BREWSTER YARDS SITE PLAN APPLICATION

FINAL ENVIRONMENTAL IMPACT STATEMENT

160 & 132 Pugsley Road - Tax Parcels: 45.-1-10 & 45.-1-11
TOWN OF SOUTHEAST, PUTNAM COUNTY, NEW YORK

Lead Agency: TOWN OF SOUTHEAST PLANNING BOARD

Figure 5-2: Sight Line Profile 1
BREWSTER YARDS FEIS

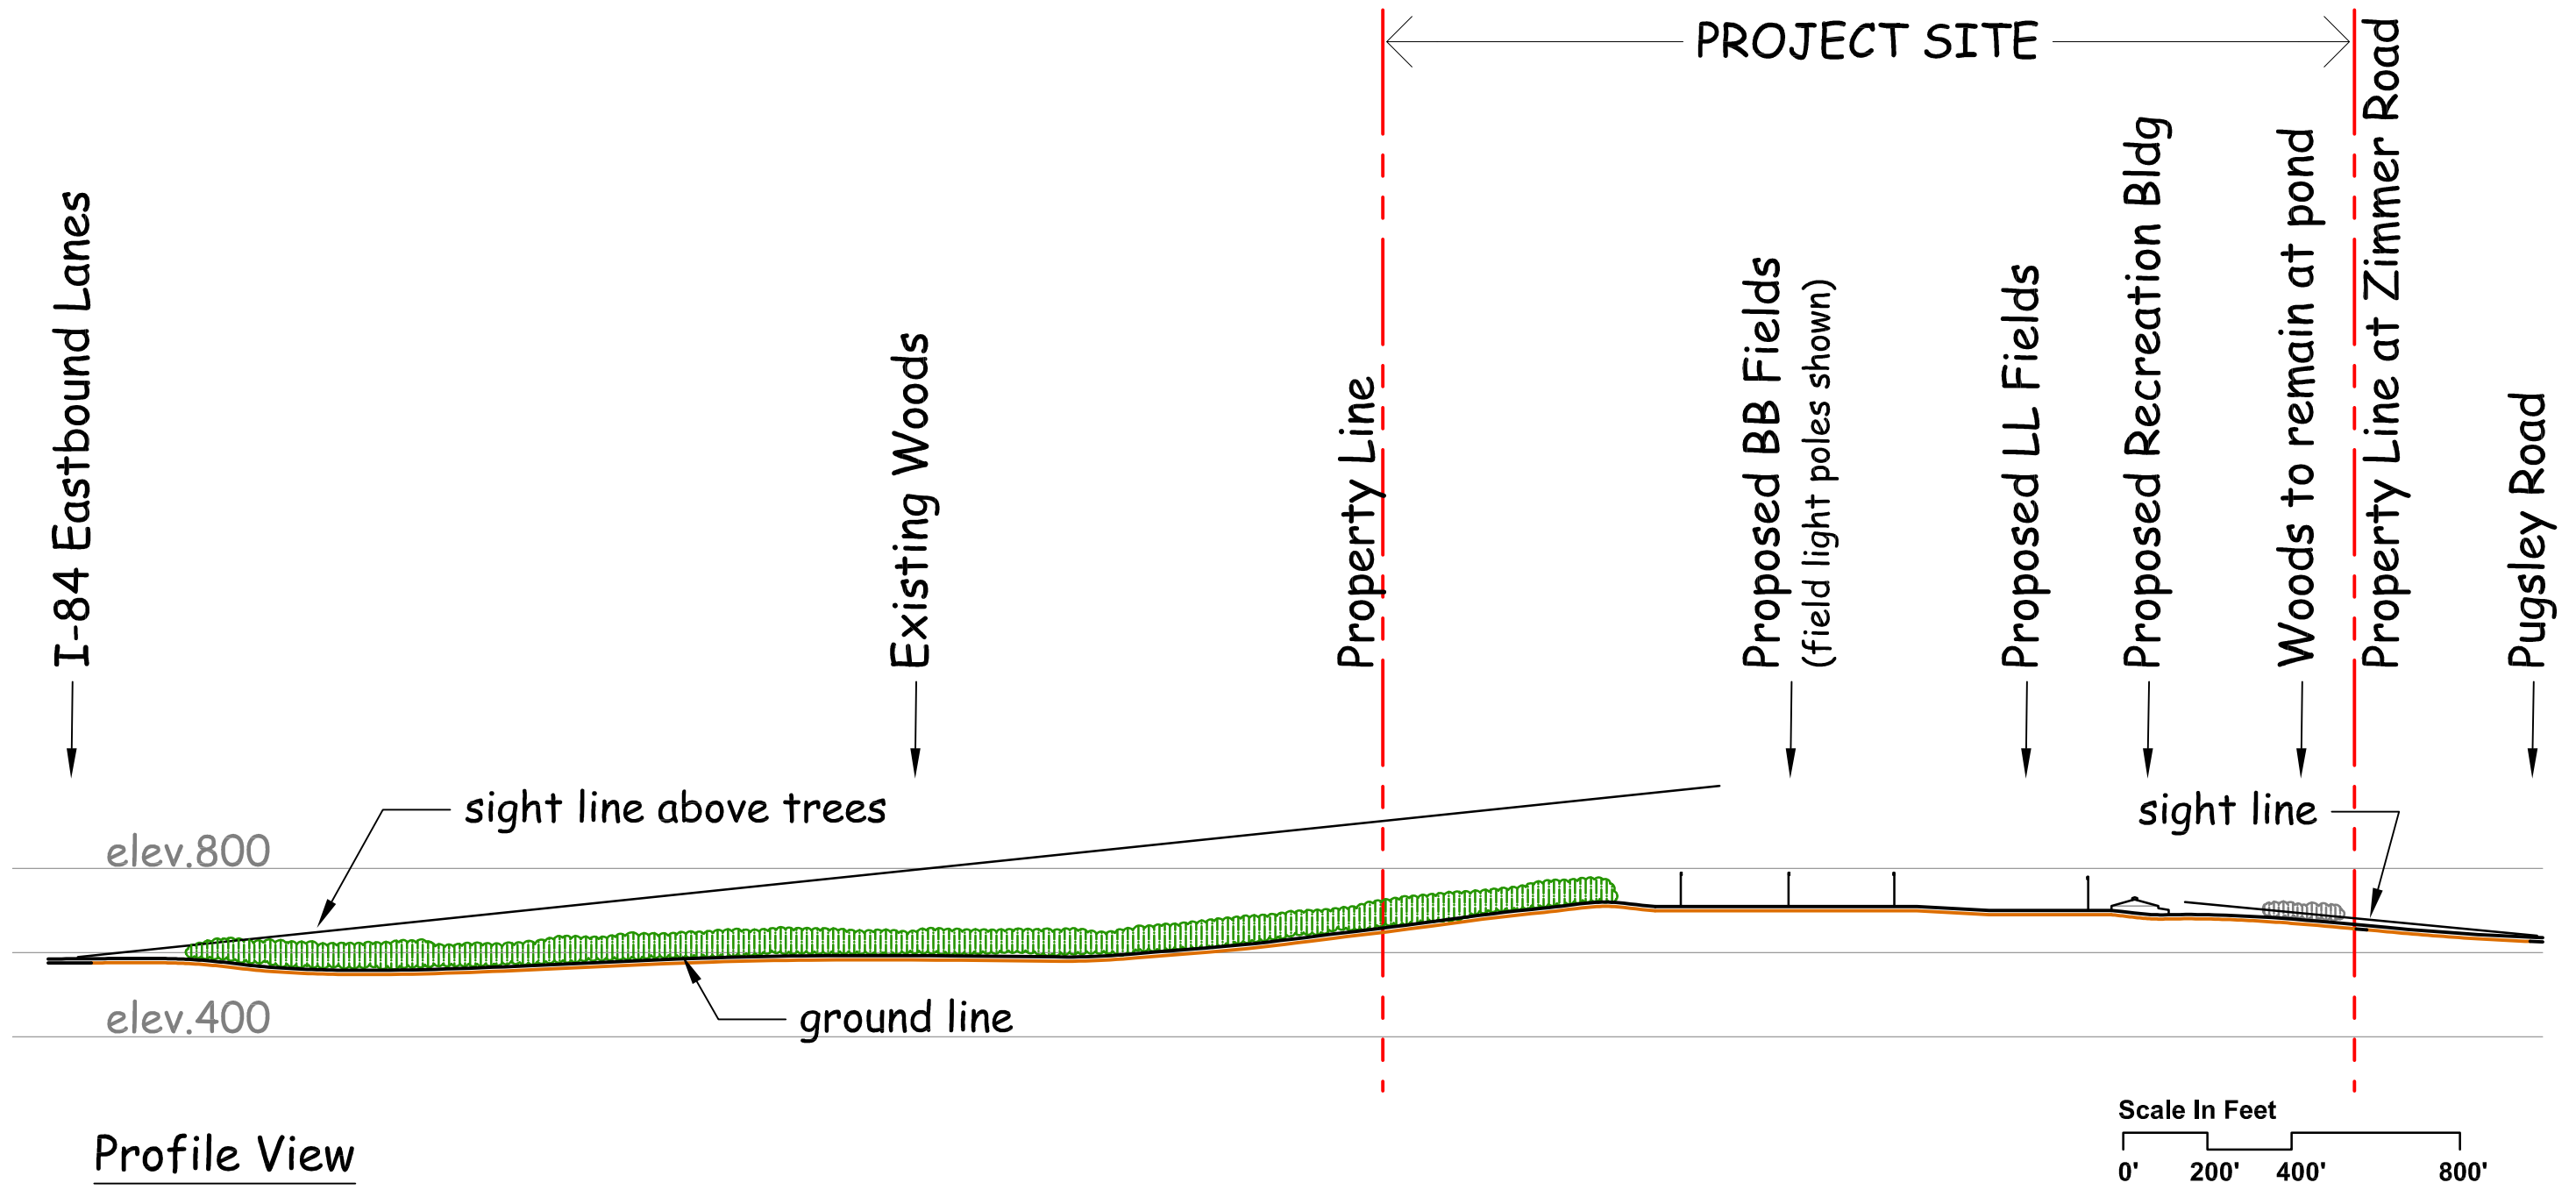
Comment 5-3 (Letter 3, AKRF 8/5/22): The DEIS indicates that “lighting designs are preliminary.” The FEIS should indicate if the height of the light poles shown on Figures 5-2 to 5-6 are actual or representative/estimated. If estimated, a note should be added to the Figures.

Response 5-3: *The height of the playfield light poles shown on DEIS Figures 5-2 to 5-6 is 80 feet. This is the maximum proposed pole height of the field lights and is so noted in the revised figures, FEIS Figures 5-2 to 5-6. Actual mounting heights will vary by location and function, generally being 60, 70 and 80 feet in height.*

This Figure depicts Sight Line Profile 1 From I-84 Eastbound taken through the project site as shown in Figure 5-1, Key Map to Visual Assessment. The height of the playfield light poles is shown at 80 feet, the maximum proposed pole height. Actual mounting heights will vary by location and function.
